DEFENSE NUCLEAR FACILITIES SAFETY BOARD

August 1, 2003

Staff Issue Report

SUBJECT: Aqueous Processing of Scrap Plutonium-238 Oxide at Los Alamos National Laboratory

Figure 2. Dissolution Filtrate Storage Vessel (Los Alamos National Laboratory, 2002b)

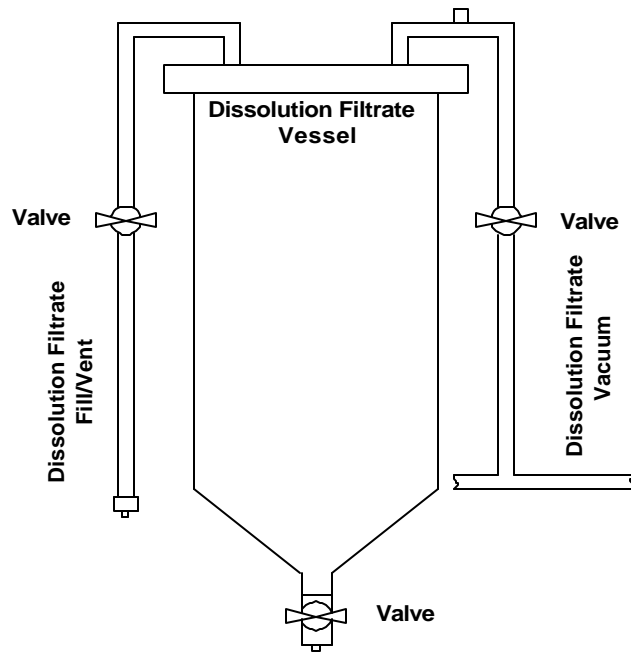
In addition, solutions transferred from the dissolver to the filtrate storage vessels will continue to generate hydrogen at the same rate. The LFL will be reached in the filtrate storage vessels within 6 hours, assuming an unvented 7 liter headspace. The stoichiometric concentration for hydrogen and oxygen will be reached in the storage vessel in less than 2.5 days.

Filtrate Storage Vessel Safety Controls—Neither the PrHA nor the SER analyzes a deflagration in a filtrate storage vessel or identifies functionally classified safety controls to prevent such an event. In response to comments from NNSA on hydrogen generation, LANL states that small amounts of hydrogen will be generated in the storage vessel (Los Alamos National Laboratory, 2003d); as stated above, the staff's analysis shows that the LFL could be reached in less than 6 hours. There are two vessels, and each has a level sensor and pressure relief valve. The pressure relief valve is not functionally classified as a safety control and should not be relied upon to preserve the vessel's integrity in the event of a hydrogen deflagration. The storage vessels do have vent lines, but there are no safety controls identified to ensure that the vent lines are open. Also, the U-shaped configuration of the vent lines will hinder the buoyant migration of hydrogen (see Figure 2). Diffusion of hydrogen will occur through the line, but no analysis has been performed to show that the equilibrium hydrogen concentration in the vessel will remain below the LFL. Since filtrate may be stored for extended periods of time, the possibility exists for flammable amounts of hydrogen to accumulate in the filtrate storage vessel. The opportunity for an ignition source in the filtrate storage vessel is less than that in the dissolver vessel, but a conservative hazard analysis should always assume the presence of an ignition source. A safety control to either vent or purge the vessel would address this accident scenario.

Figure 3. Resin Color as a Function of Alpha Dose (Marsh, 1991)

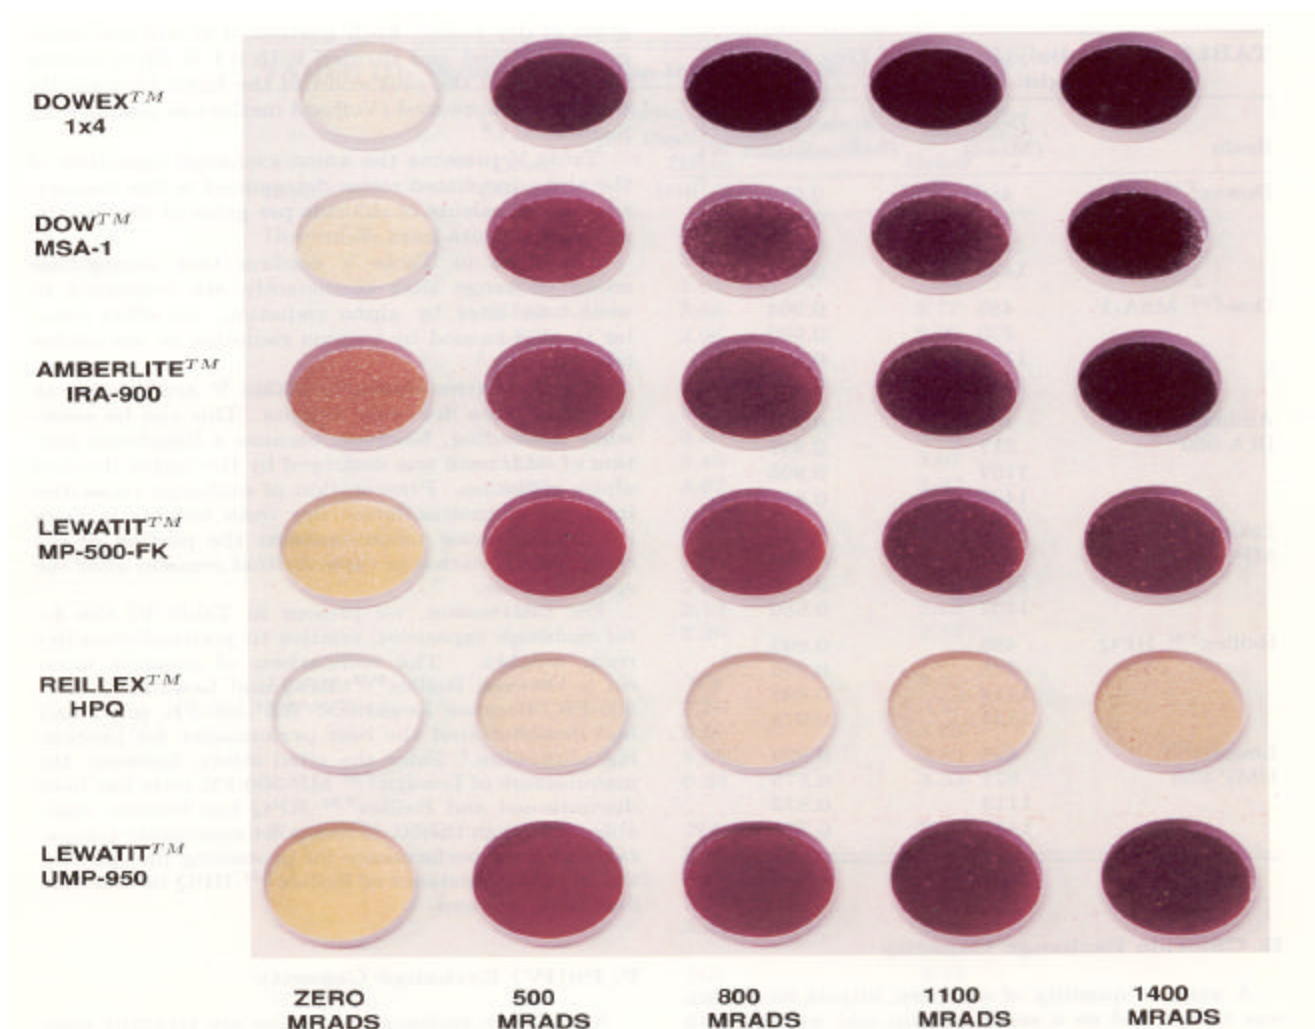
The revised PrHA proposes surveillance of resin exposure in addition to annual resin replacement, but the PrHA and the SER do not explain how this surveillance will be performed. Furthermore, the December 2000 SER imposed what was intended to be a safety factor of two for the resin lifetime. The newly proposed controls accept a reduced safety factor. This reduction in the safety factor, combined with a potentially nonconservative estimation of resin dose, could result in an unsafe resin condition.

Figure 4. Maximum Resin Temperature for Loss of Flow, Maximum Concentration, and Double Loading (Laurinat, J. E. and M. E. Pansoy-Hjevnik, 1999)

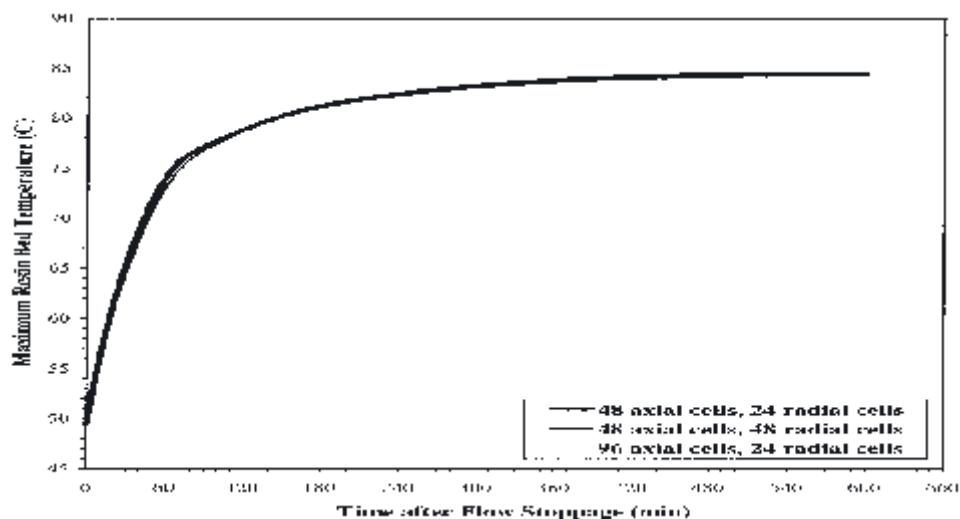
Thermal Analysis—The May 2003 PrHA states that the resin temperature can reach a maximum of 50°C. A thermal analysis was performed by Westinghouse Savannah River Company to determine the maximum temperatures of the ion exchange column (Laurinat and Panson-Hjevnik, 1999). The analysis demonstrated that the column temperature would remain below 50°C under normal operating conditions. However, the calculation concluded that the column could reach approximately 84°C under abnormal conditions (see Table 1 and Figure 4). This scenario assumes that the resin has been loaded with twice the normal quantity of Pu-238 and that there is no flow of solution through the column. High column temperatures would degrade the resin, leading to further heat evolution. The column could eventually dry out or pressurize from evaporated water. Moreover, if the column heated to such a temperature, self-heating of the resin could initiate, as shown by the bomb calorimeter testing discussed below.

The staff believes the abnormal conditions that could lead to self-heating of the resin are credible. The pumps that provide solution flow through the columns are not functionally classified, and their reliability was not considered in the hazard analysis. Furthermore, although loading two batches of Pu-238 on the resin columns is not allowed in the operating procedure (Los Alamos National Laboratory, 2002d), the resin is physically capable of holding significantly more than a double batch of Pu-238. Kyser (2000) has demonstrated that the 2 liter volume of the Reillex HPQ resin to be used in the column can adsorb 234 g of

Pu. LANL has provided the Board's staff with documentation indicating that the maximum weight percent of Pu-238 in the scrap Pu feed material is 85 percent. Therefore, a column could be loaded with up to 198.9 grams of Pu-238, whereas the double-batch scenario in the thermal analysis considered only 150 grams of Pu-238. The maximum temperature of a fully loaded column has not been analyzed, but would likely be substantially greater than 84°C if there were no flow of solution through the column.

Figure 5. Rate of Thermal Increase as a Function of Resin Temperature (Crooks, W. J., 2001)

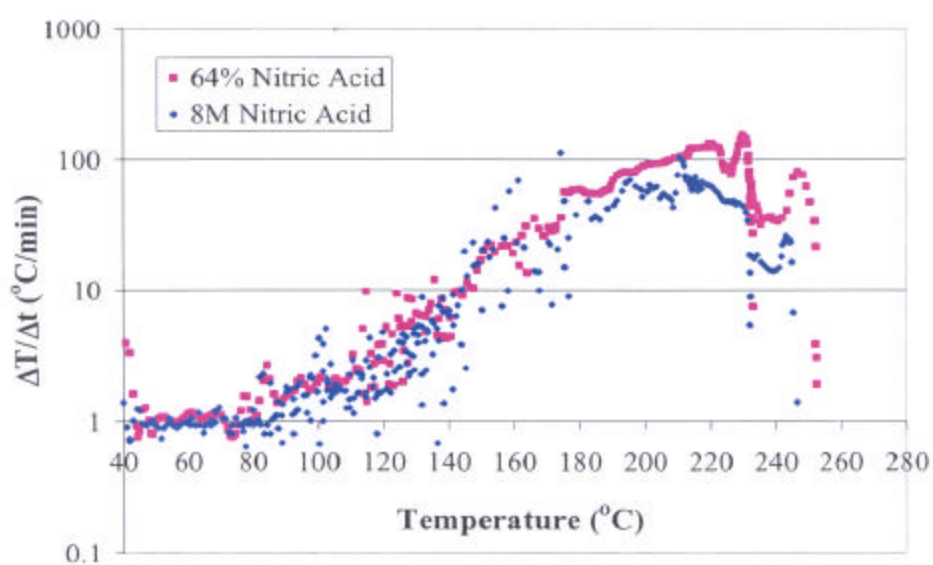
The PrHA indicates that the resin remains safe for temperatures below 120°C. However, Crooks (2001) has shown that the Reillex HPQ resin may initiate self-heating at temperatures as low as 81°C in a calorimeter. The bomb calorimeter was used to allow external heating of the resin at a rate of 1°C per minute to determine resin stability as a function of temperature. The external heating may also simulate the increase in temperature due to radioactive decay upon loss of flow. Figures 5 and 6 show that self-heating begins at approximately 81°C, and temperatures proceed to climb quickly. Resins tested in 8 M and 12 M nitric acid reached a maximum temperature of approximately 250°C in 1 to 2 hours.

Figure 7. HAN/HNO₃ Instability as a Function of Temperature (U.S. Department of Energy, 1998)

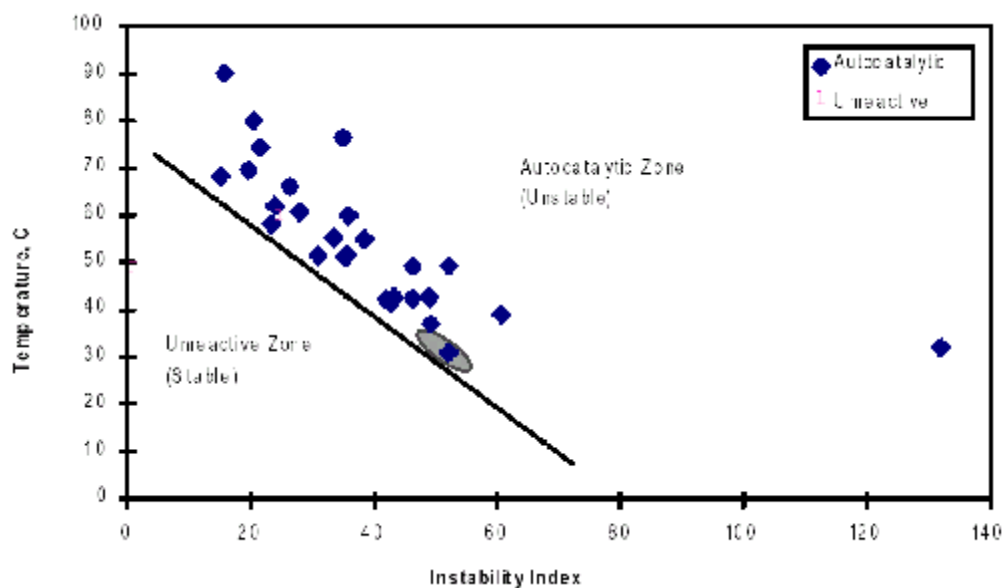
The HAN used in the recovery line is 2.8 M. DOE's technical report suggests that HAN concentrations below 2–3 M lack the necessary energy density to generate high pressures or explosive reactions. Therefore, the 2.8 M HAN solution used by LANL appears to be in an intermediate range with respect to energy density. At a HAN concentration of 2.8 M, the heat of reaction may vaporize enough water to concentrate the HAN and thus increase its energy density to an unsafe regime.

The March 2000 PrHA did address reactivity hazards of HAN, but identified no functionally classified controls. The Board's April 2002 letter stated that LANL had yet to demonstrate how the recommendations provided in DOE's technical report on HAN had been implemented in the recovery line, as required by NNSA's December 2000 SER. The January 2003 and May 2003 PrHAs reanalyze the consequences of a HAN/nitric acid reaction and propose dual independent administrative verifications of acid concentration to prevent undesirable reactions. This control is not captured as a TSR. Given the numerous other administrative controls, it is not clear to the Board's staff that the verification of acid concentration will be implemented with a rigor commensurate with its importance to worker safety. The report of a LANL readiness review of the aqueous recovery line performed in July 2002 concluded that overuse of second-person verifications limits their effectiveness (Los Alamos National Laboratory, 2002e). The staff believes verification of acid molarity would be implemented with greater certainty if specified as a TSR.
